# 2001 Annual Report Monitoring Events 18 and 19 Sites 1 and 3 and Eastern Plume Naval Air Station, Brunswick, Maine

Contract No. N62472-92-D-1296 Contract Task Order No. 0047

# RESPONSE TO COMMENTS FROM - MAINE DEPARTMENT OF ENVIRONMENTAL PROTECTION ON THE DRAFT SITES 1 AND 3 AND EASTERN PLUME 2001 ANNUAL REPORT NAVAL AIR STATION, BRUNSWICK, MAINE

Figure 2-1. Water elevations within the Sites 1 and 3 landfill, shallow and deep wells.

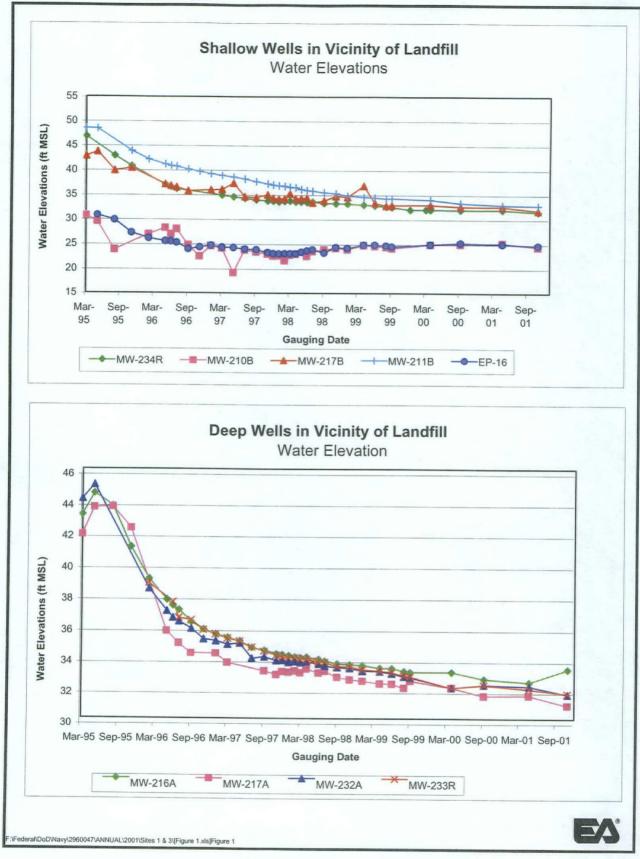
Figure 2-1 shows trends in the potentiometric water surface elevations at landfill wells from 1995 to 2001. Figure 2-2 compares water elevations measured during 2001 to waste elevations and

# Attachment Revised Figures and Tables

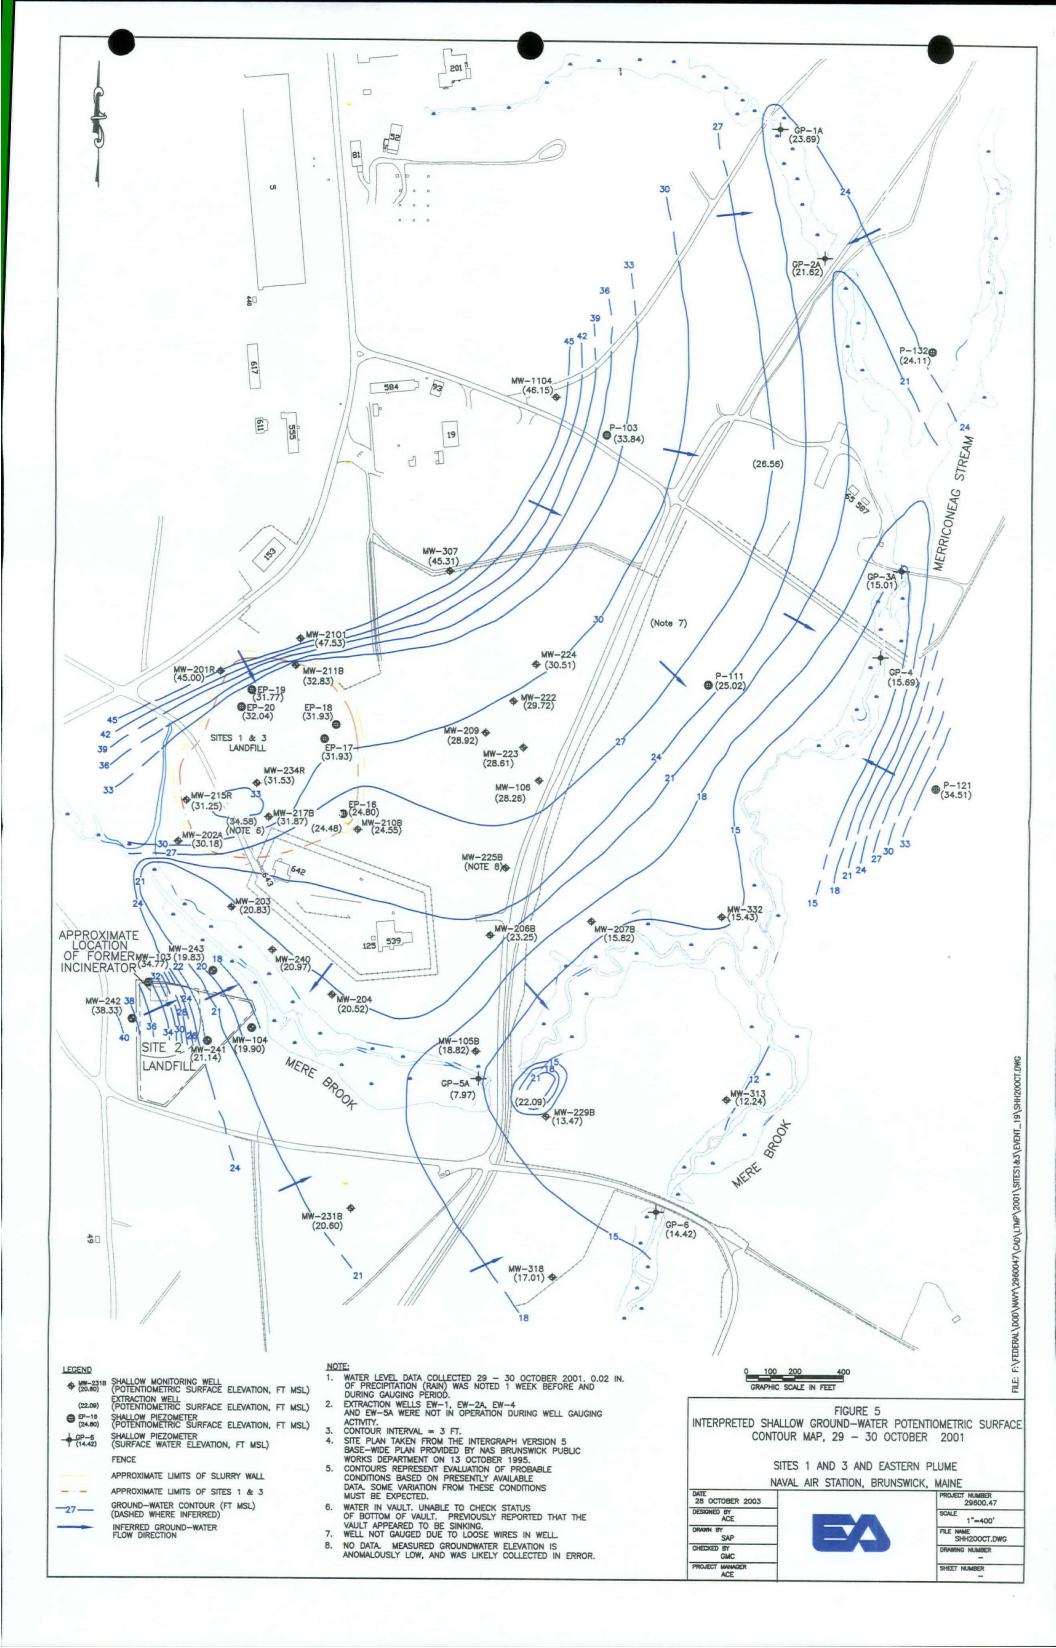
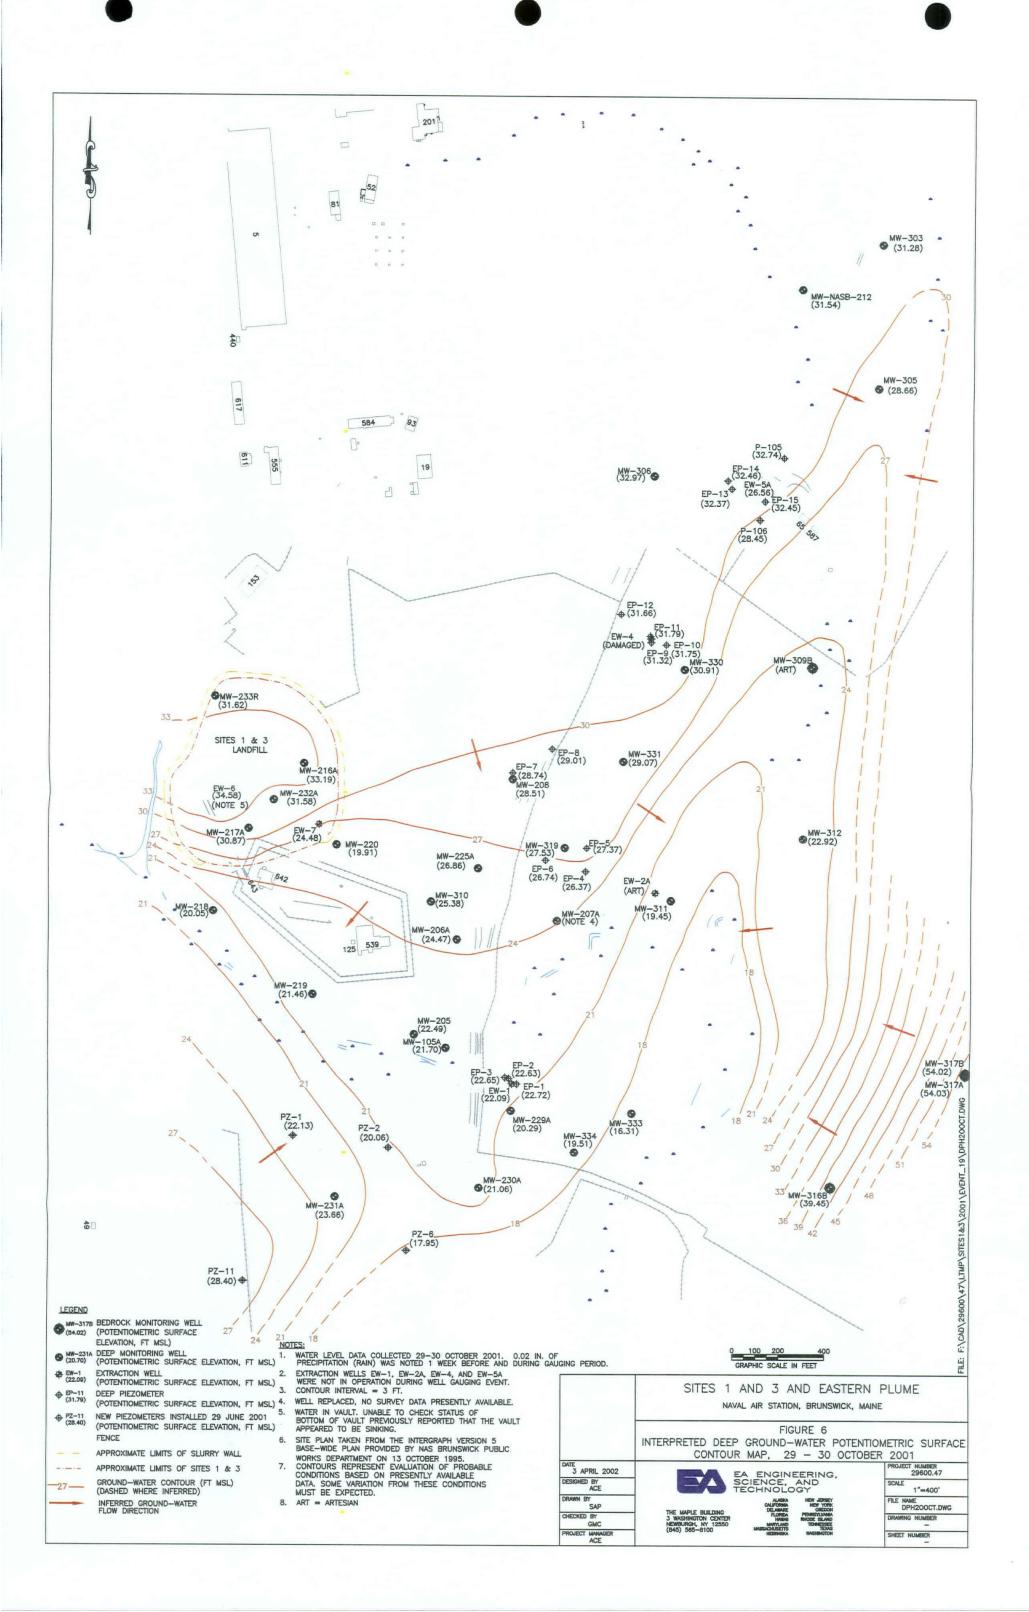
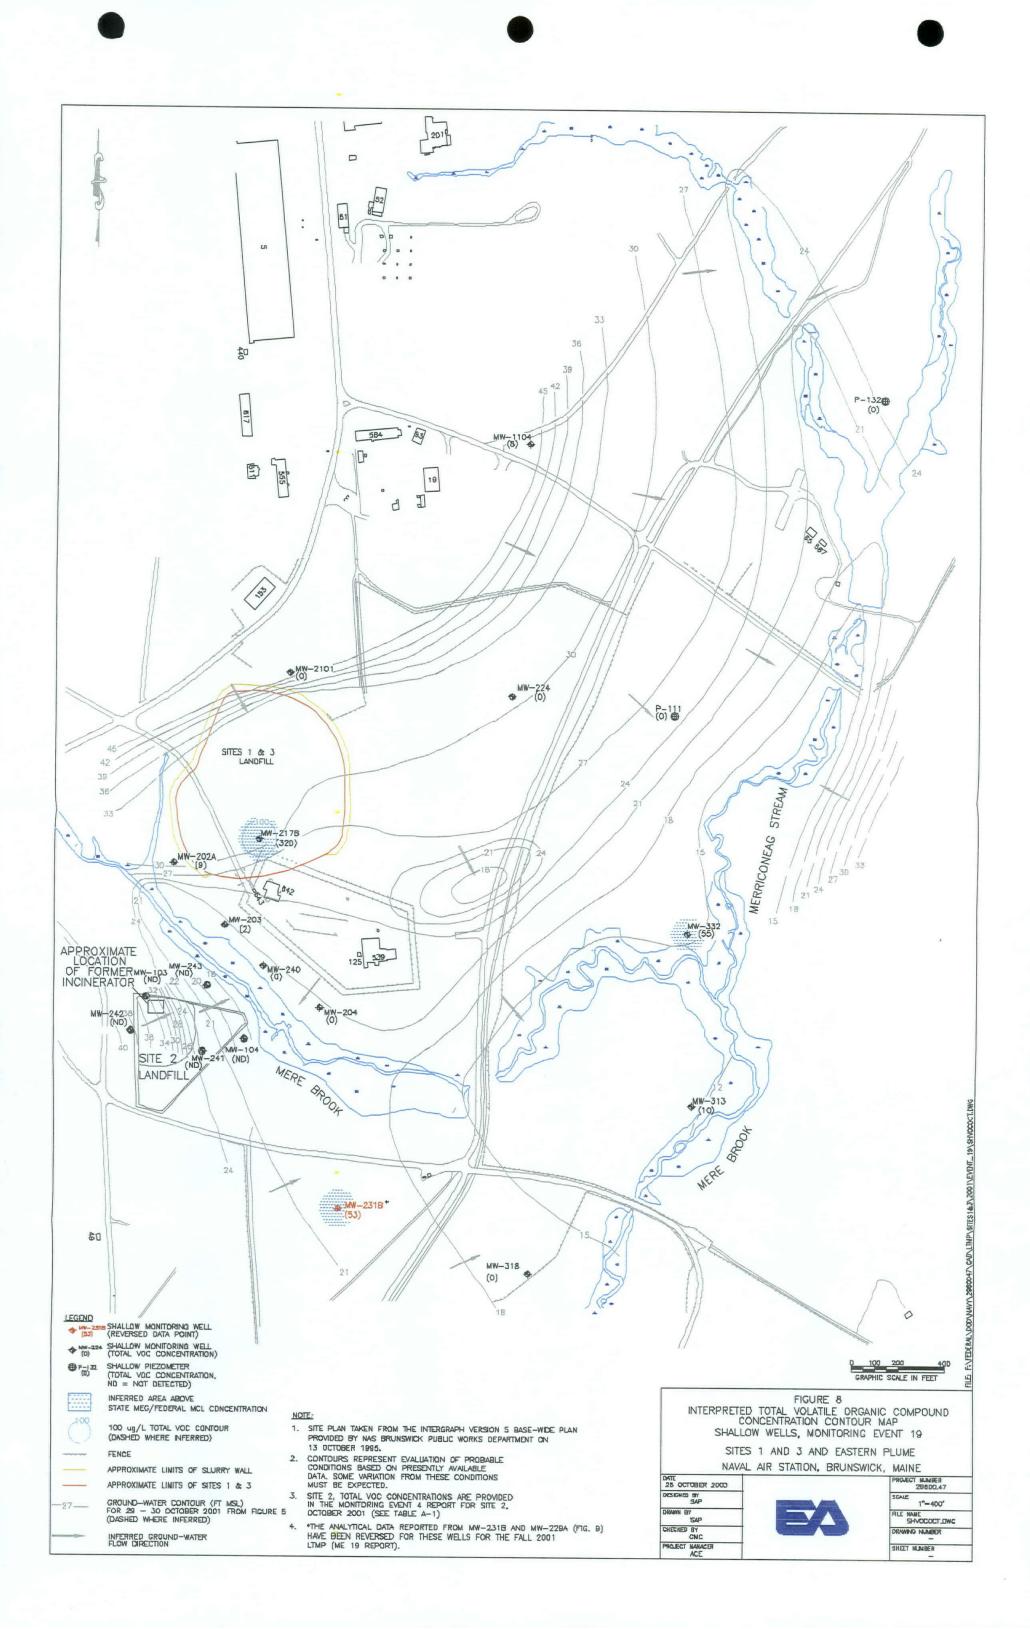
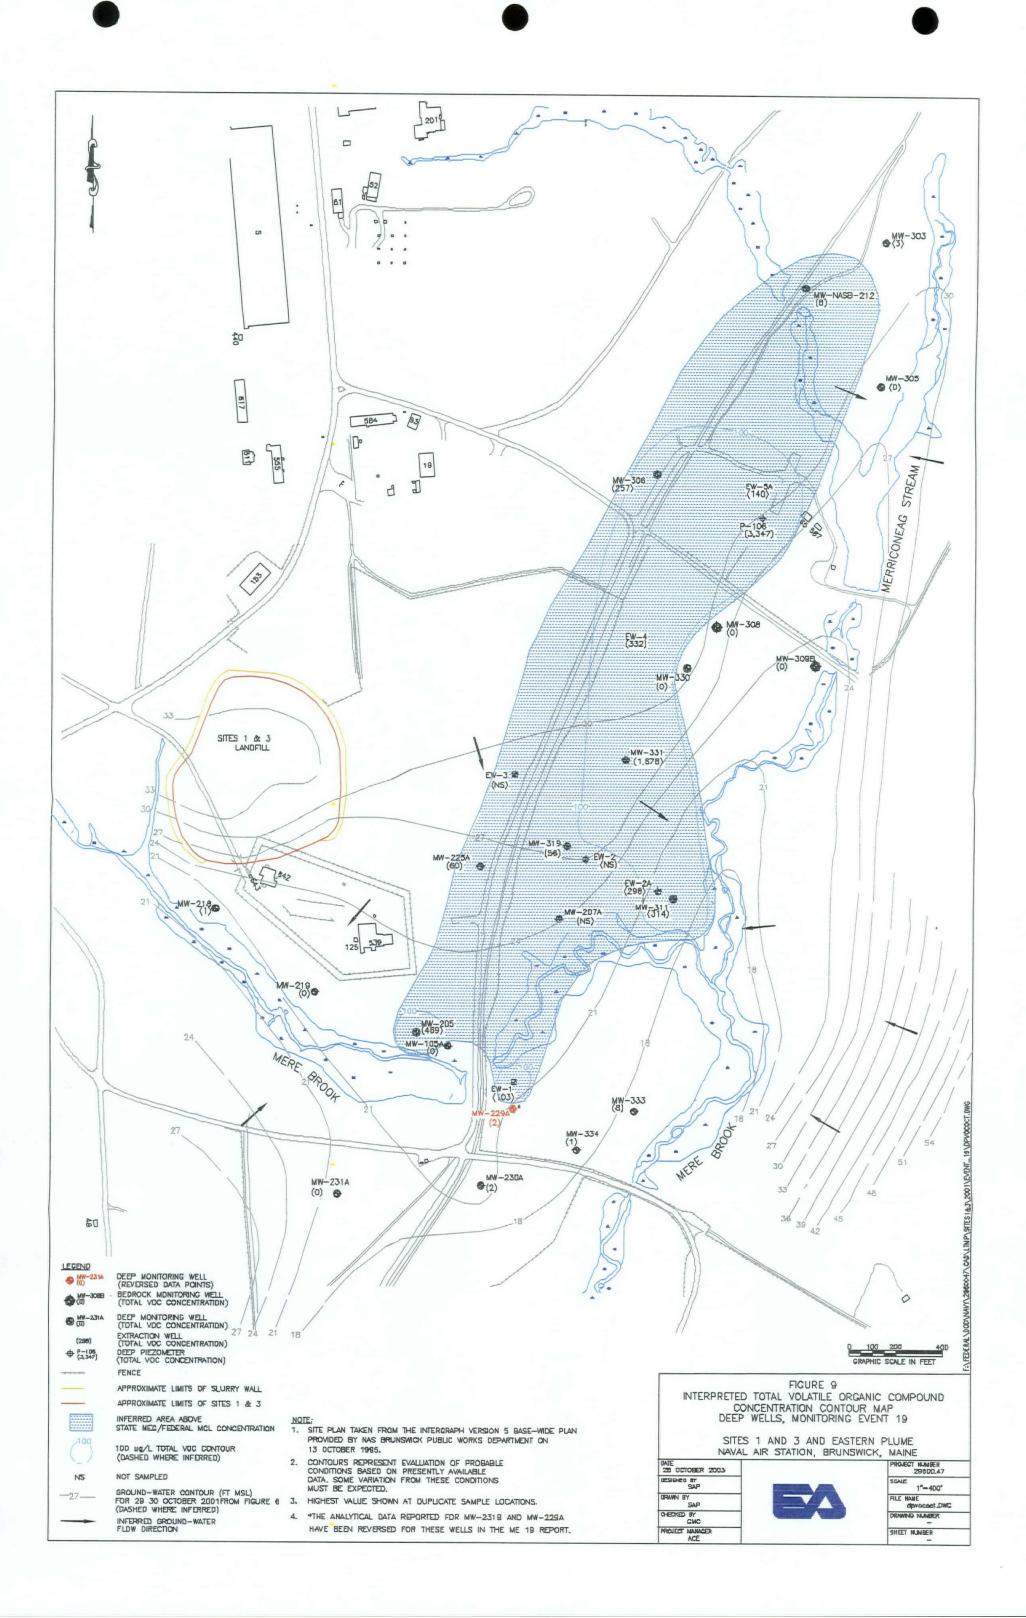
- a. The Navy acknowledges that the groundwater elevation measured in MW-225B is anomalously low, and attributes this to field error. The water level is over three feet lower than past elevations measured (specifically, Monitoring Event 17, September 2000). In response to MEDEP comment 8.b, of our letter of July 24, 2002, the Navy stated "There is no well in the Weapons Area, or other potential "sink" of ground water." If this is the case, the data recorded at MW-225B are likely due to field measurement error, and these data should have been flagged as unreliable on this map. Due to this field error, the elevation for MW-225B should not have been used for contouring on Figure 5 in Monitoring Event 19, the value should be removed from the map with a notation to explain this action. Figure 5 in Monitoring Event 19 must be redrawn and reissued to avoid erroneous depiction to shallow groundwater potentiometric surface contours. (ED/RR)

Comment on Response—Please discuss how the Navy proposes to handle this error in Monitoring Event Report 19.

24. Appendix B-3, Navy's Response of MEDEP Comment 9, 24 July 2002—Upon re-examination, MEDEP stands by its original statement that the water level measurement for MW-231A is incorrect in Table 4, and that when corrected, a value of 23.66 feet above sea level will result. The value of 23.66 feet needs to replace 20.70 feet on Figure 6 in the Monitoring Event 19 Report, and contours redrawn. (ED)

Comment on Response—A revised Figure 6 was not received by MEDEP.

**Response**—We agree that these data were collected in error. The revised Figure 5 from Monitoring Event 19 to remove this data point is attached to this response to comment document.

**Response**—The revised Figure 5 from Monitoring Event 19 will have this data point removed, and is attached to this response to comment document.

**Response**—The field data sheet for MW-231A from Monitoring Event No. 19 was checked and the correct groundwater elevation is 23.66 ft MSL. The groundwater contour map (Figure 6) is attached.

**Response**—EA forwarded Figure 6 to MEDEP on 18 July and 1 August 2003 along with the response to comments on the 2001 Draft Annual Report. A revised Figure 6 is attached to this response to comment document.
